Town of Rolesville, NC
Department of Planning

Comments on #CID-26-0006 - Planning & Zoning: Construction Infrastructure Drawing

Application Number: #CID-26-0006
Application Type: Construction Infrastructure Drawing
Date: May 27, 2026
Address: 0 Rolesville Rd

SHEET NO.:
C1.3

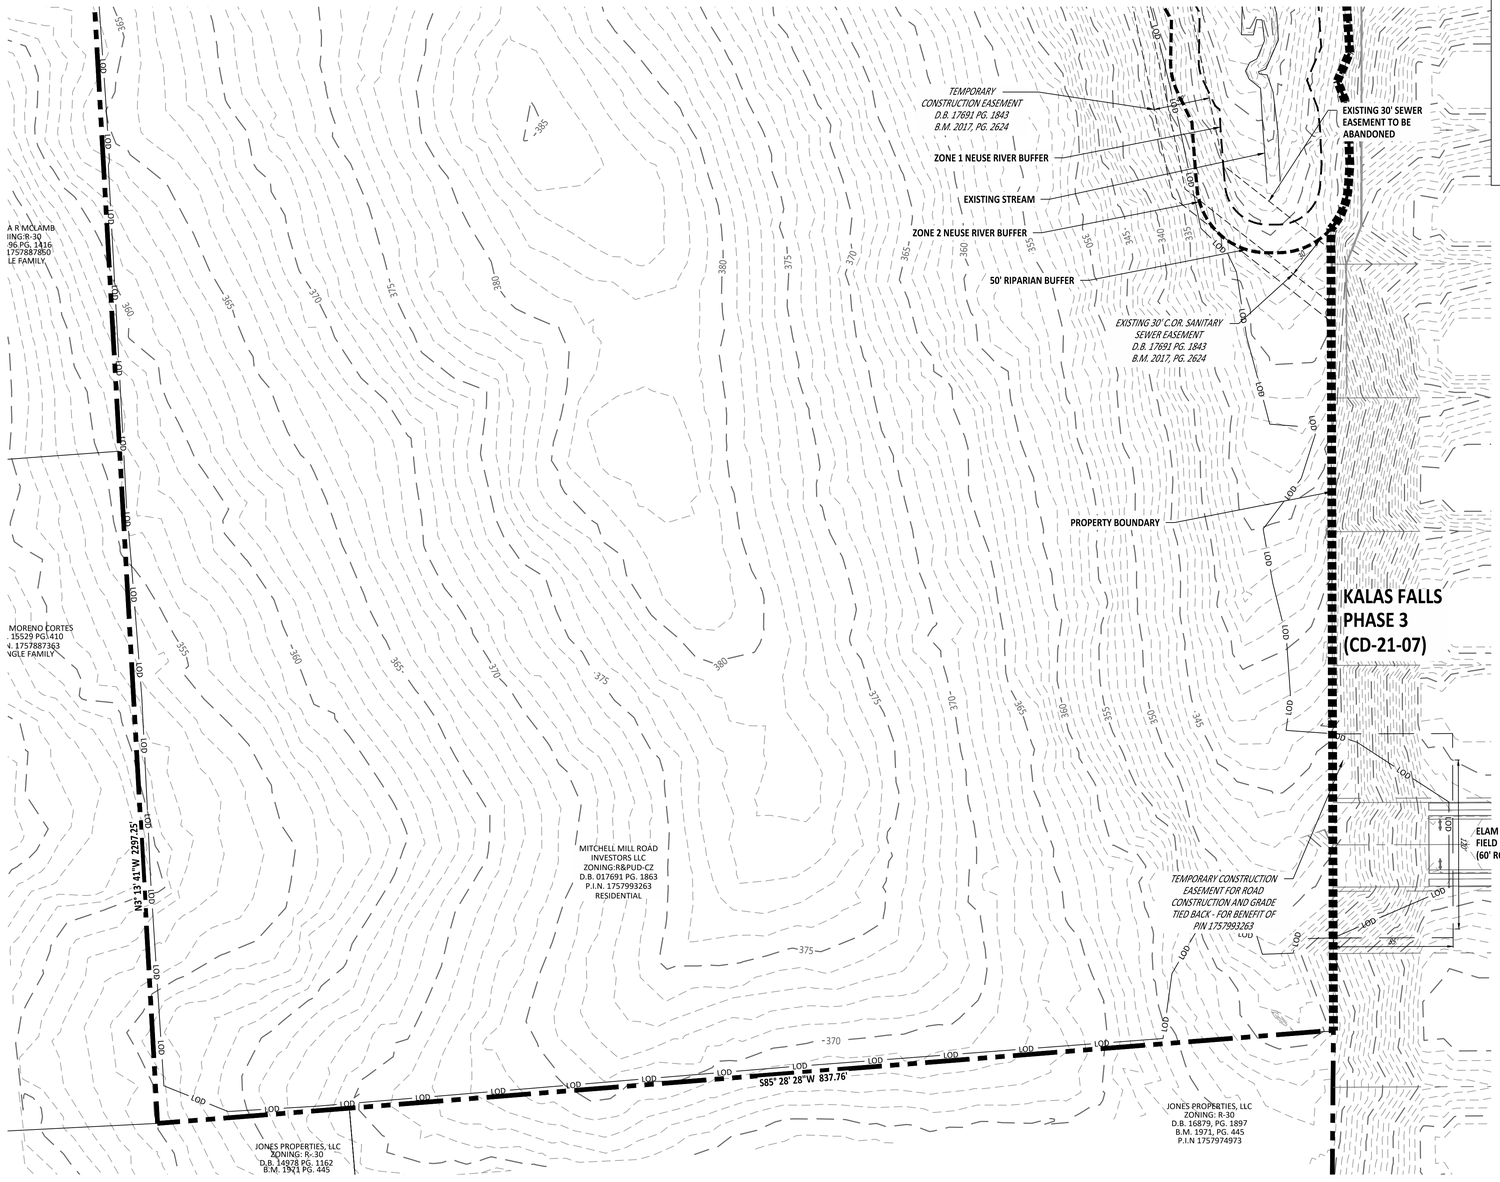
21 **Jacqueline Thompson**
Provide street names

SHEET NO.: C3.2

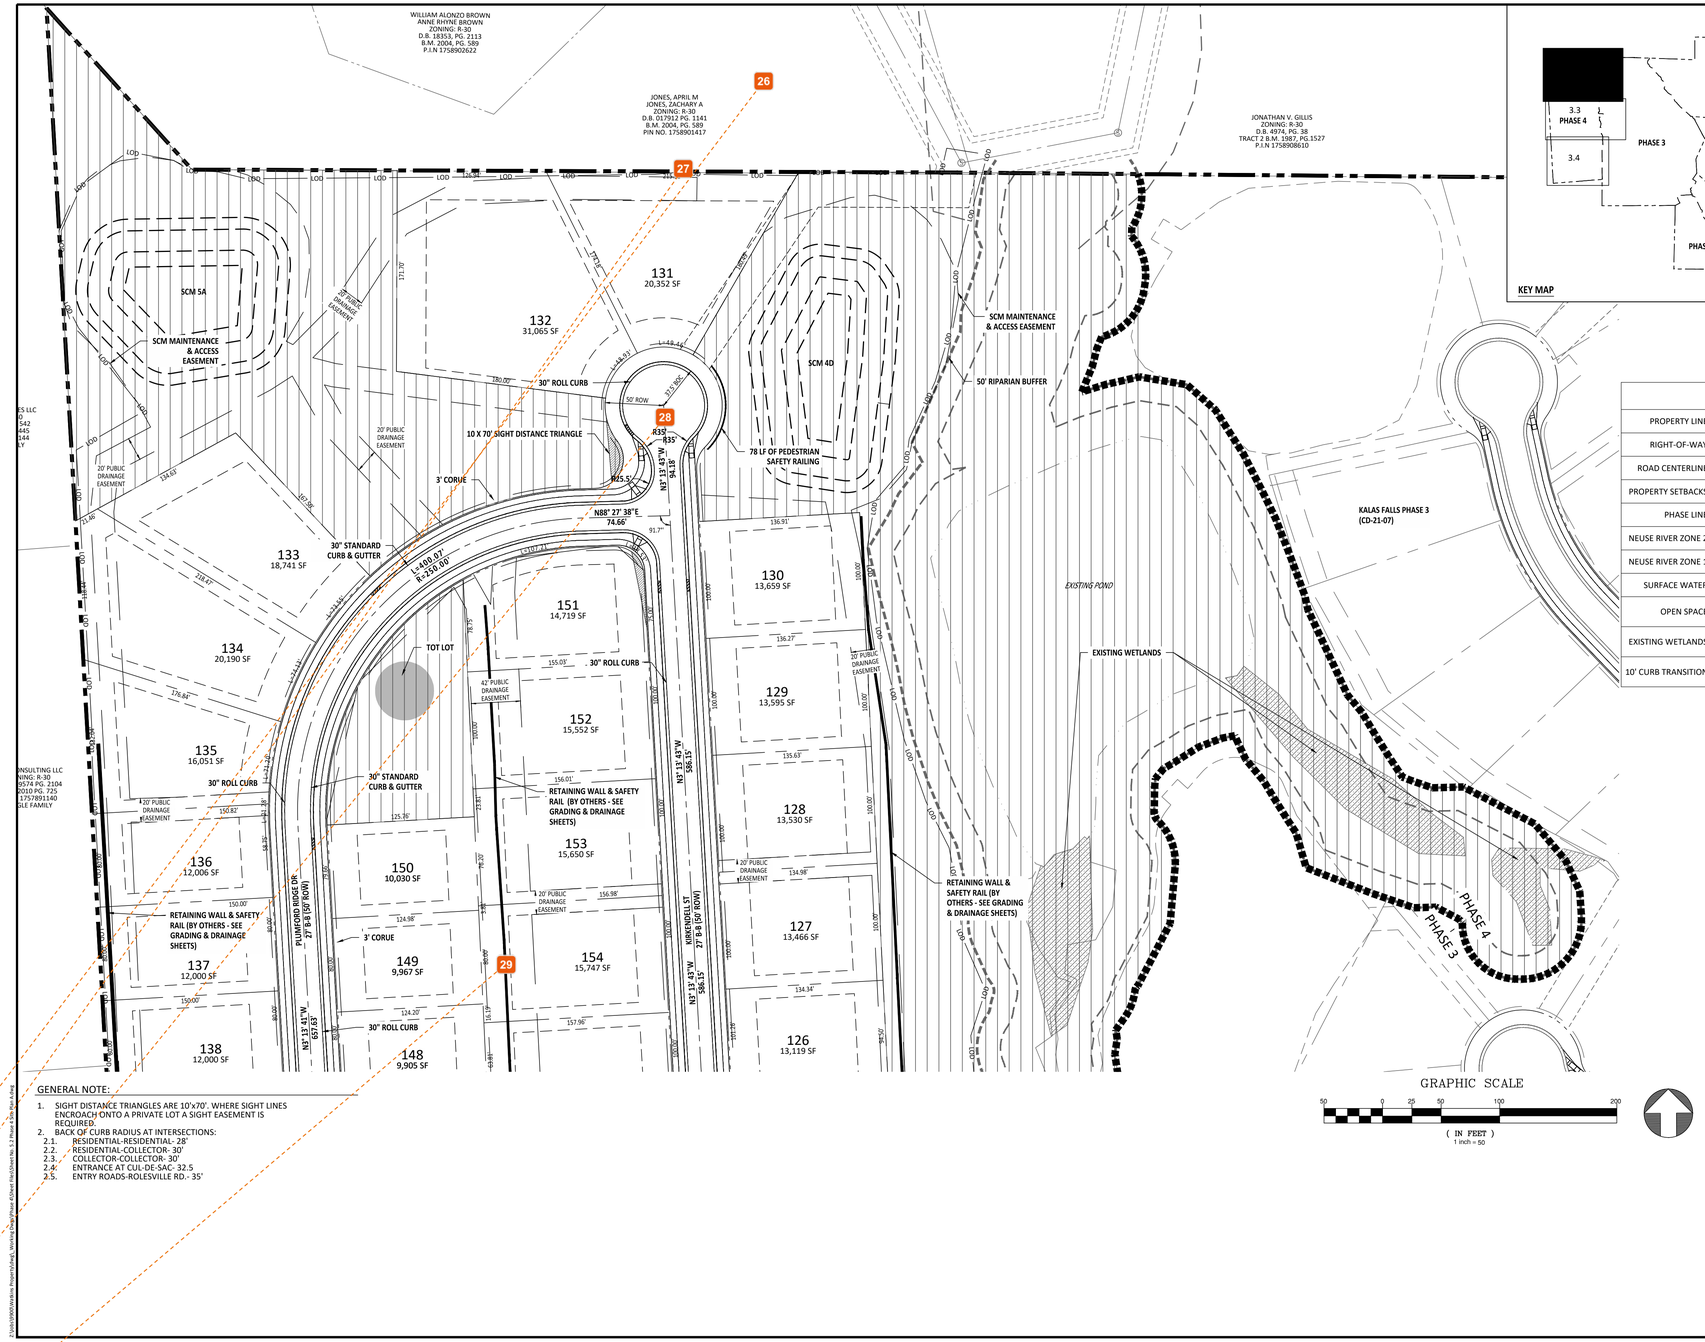
25 **Michele Raby**
REATINING WALLS REQUIRE ADDRESSES. PLEASE ADD A RETAINING WALL IDENTIFICATION TABLE.

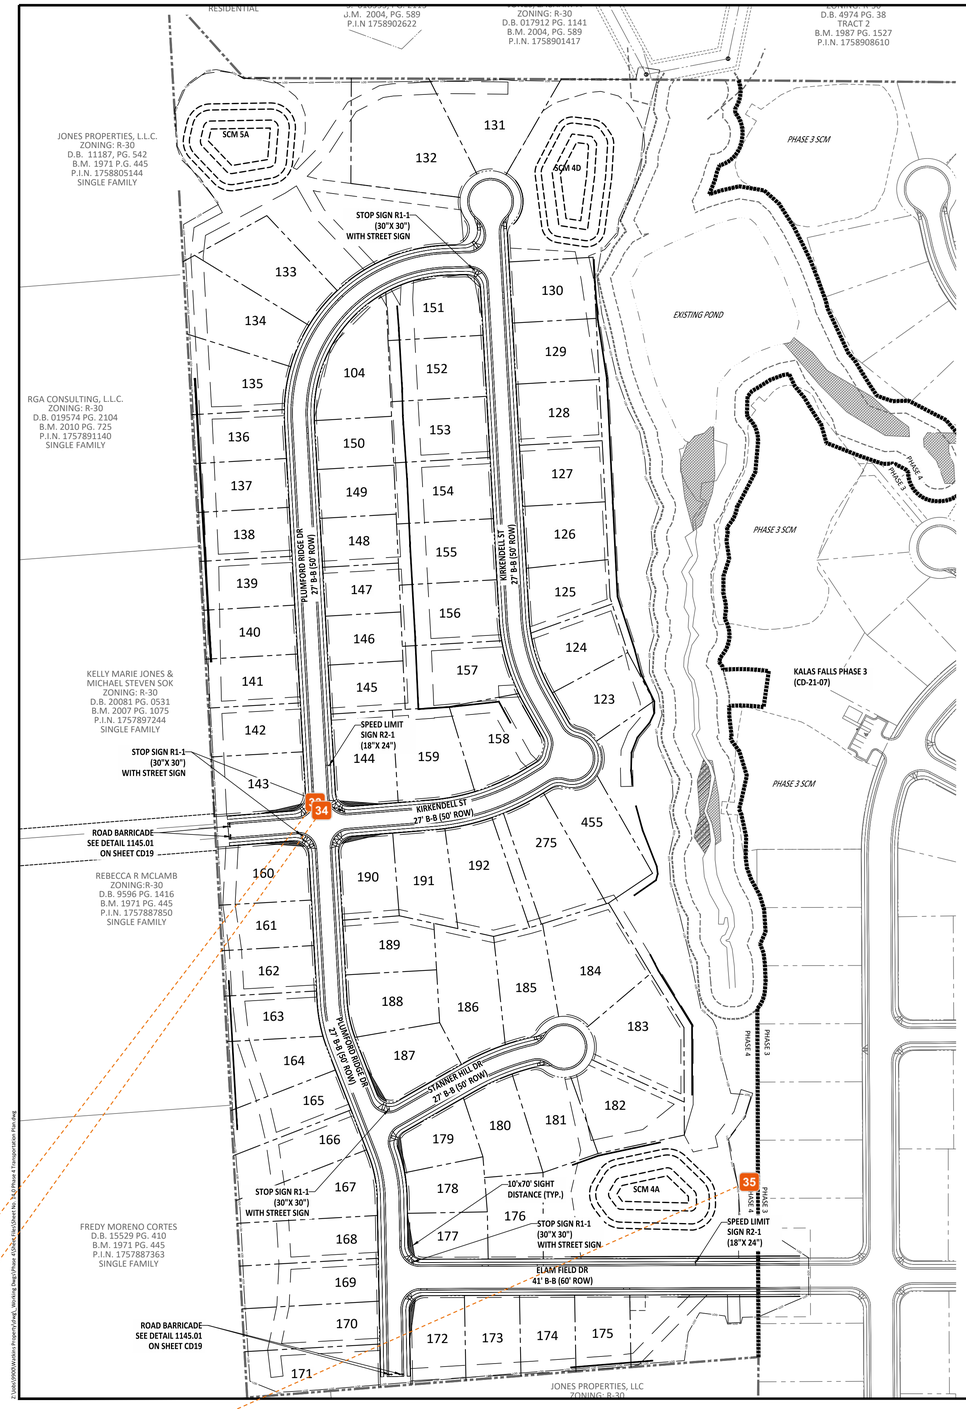
32 **Stephen Wensman**
Does the cul-de-sac meet Fire Code requirements?

SHEET NO.:
C4.0

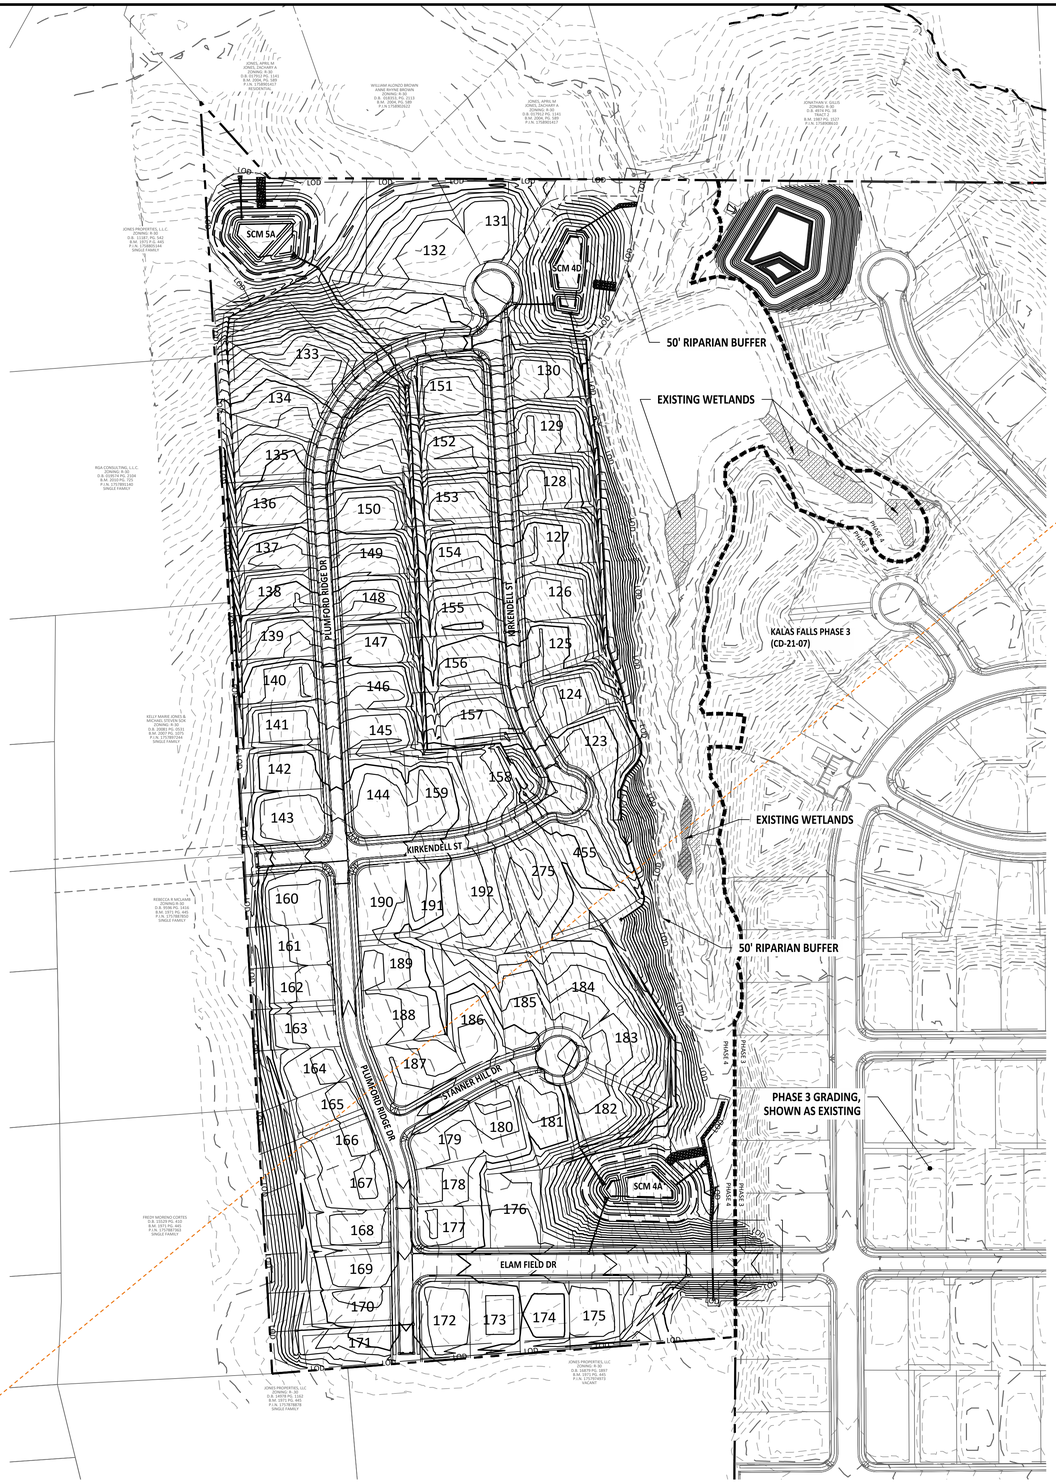
35 **Jacqueline Thompson**
Please define what the speed limit signs will be (25 mph? 35 mph?)

SHEET NO.:
C6.1

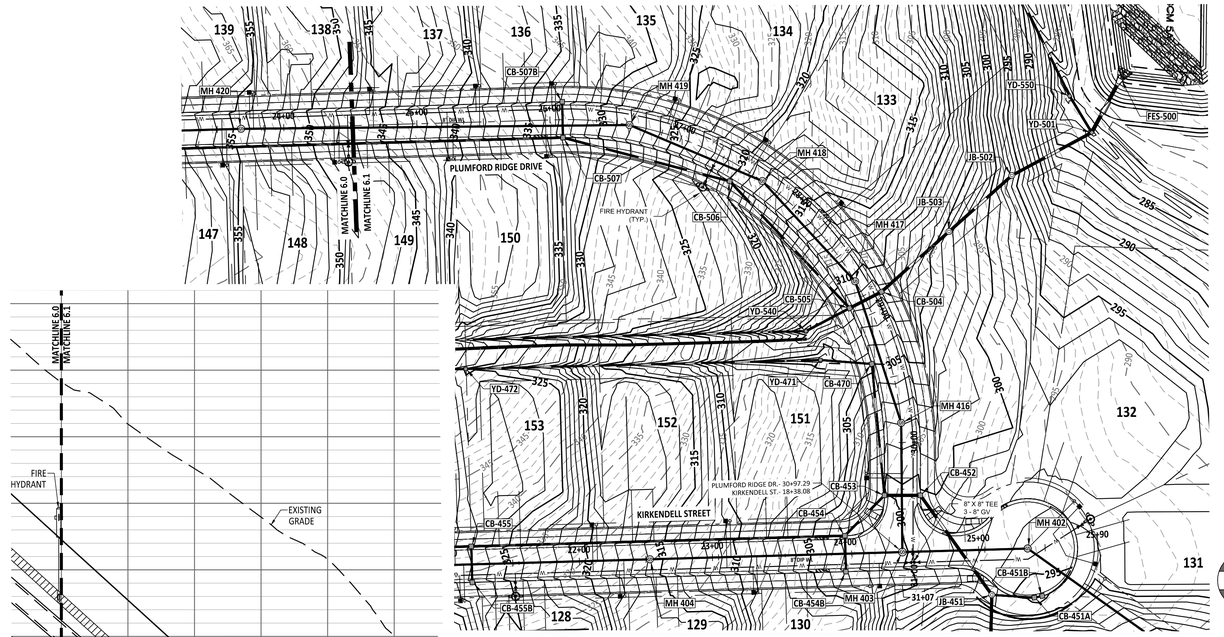
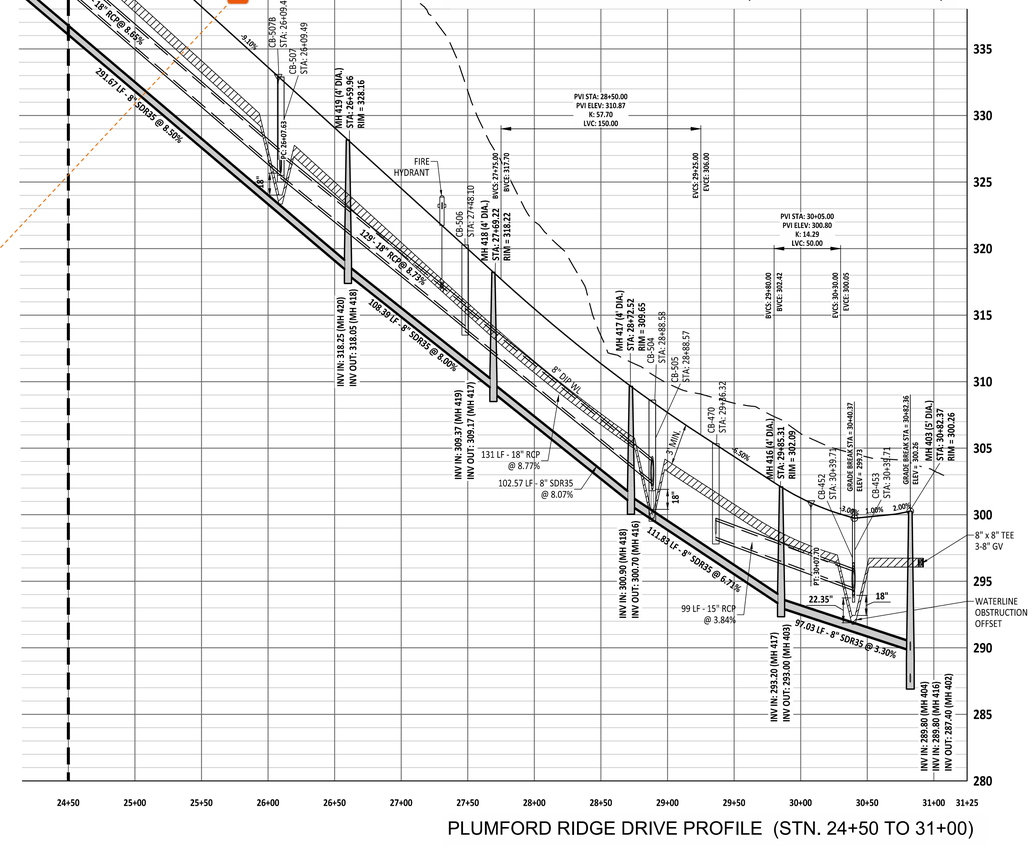
46 **Jacqueline Thompson**
Minimum 18" separation should be provided between utility crossings

SHEET NO.:
C7.0

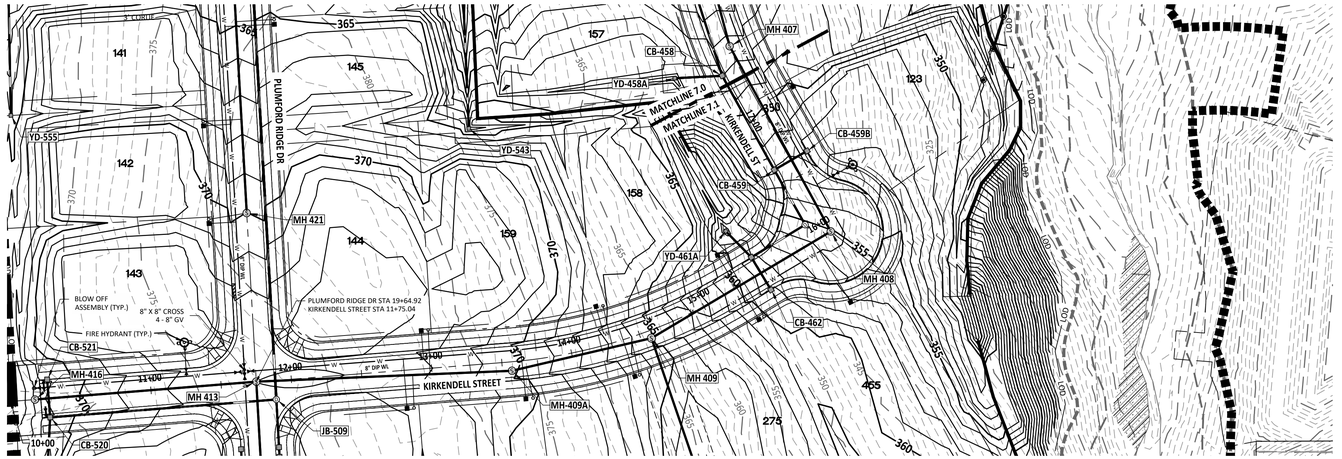
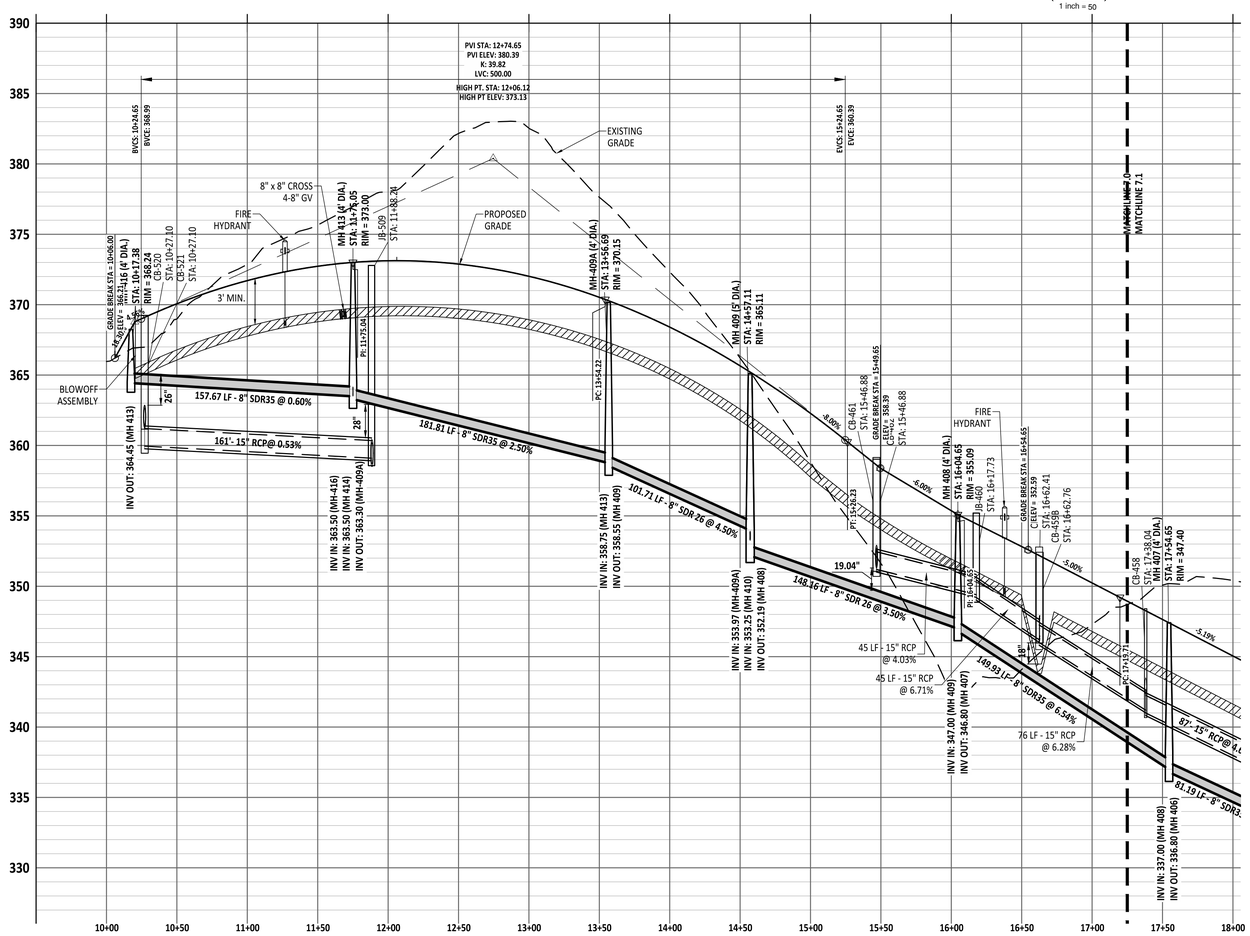
47 **Jacqueline Thompson**
The Town has implemented a new ADA policy for sidewalks adjacent to streets that cannot meet ADA compliance. For sidewalks steeper than 5% a steep grade warning sign (W7-3P) shall be installed approximately every 300 feet. It should be considered whether sidewalks are warranted when grades are greater than 8%. Please review all grades and update the signing and striping plan accordingly.
